# Triton Knoll Offshore Wind Farm Limited Triton Knoll Electrical System

**Appendix 12: Response to  
submission from Orby Parish  
Council at Deadline 3**

**Appendix 12 of the Applicant's  
Response to Deadline 4**

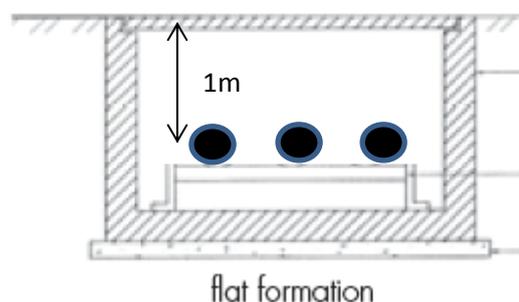
*With this in mind then the Environmental Statement – Volume 3, 1.112 quotes that National Grid Data indicates that the maximum magnetic flux density from a 400kV cable buried 1m below ground would be about 100 $\mu$ T at 1m above the ground directly over the cable and that potential electromagnetic fields from the onshore electrical circuits will comply with the ICNIRP recommended exposure limits for the public.*

*Given that a 400kV circuit would produce substantial quantities of heat, thus meaning that the trefoil presentation of the 3 cable phases is highly unlikely, therefore insufficient data has been presented to enable this calculation which is essential to demonstrate compliance with the DECC Code of Practice and thus it CANNOT be proven that EMF's produced by the cable circuits either individually or cumulatively (6 trefoils @ 3.5m spacing) will be within safe limits. Concern should also be raised with regards to the reported potential for an increase in the EMF at joint pits situated every 600-1000m along the entire length of the route, once again by omission of data the impact does not appear to have been considered."*

- 1.33 In order to address the comments made by Orby the Applicant has undertaken to demonstrate, by calculation, the potential levels at 1m above the ground for a single cable and a flat formation of cables.

- 1.34 A trefoil arrangement would have greater EMF cancelling properties than a flat formation. A flat form formation has therefore been used and modelled. This represents a realistic worst case scenario for the Applicant and landowners as the cables will be laid in a flat formation in the link boxes (giving rise to the higher levels of EMF found at link boxes), even if the rest of the trench is in a trefoil arrangement.

- 1.35 The Applicant confirms that the ICNIRP limit for safe levels of EMF is 200 $\mu$ T at a distance of 1 m above the ground, for a buried cable (cables are typically 0.9m to 1.5m; for the purposes of this consideration, we have assumed 1m). The ICNIRP guidance limits were increased in 2010 for an AC system with 50Hz from 100 $\mu$ T to 200 $\mu$ T.

- 1.36 For the proposed development, 900 MW transmission, through 6 circuits at 132 kV, gives a current flow of approximately 656 A in each circuit. For the purposes of a precautionary (maximum) calculation a current of 1000 A has been used; a higher level

- 1.37 The electric field (V/m) is contained within the cable due to the earthed shielding around the cable; this is the case throughout the length of the cable, even at joints.
- 1.38 The magnetic field is a function of the current in the cable, and 1000 A has been assumed.
- 1.39 Below is a representation of one circuit in flat formation.
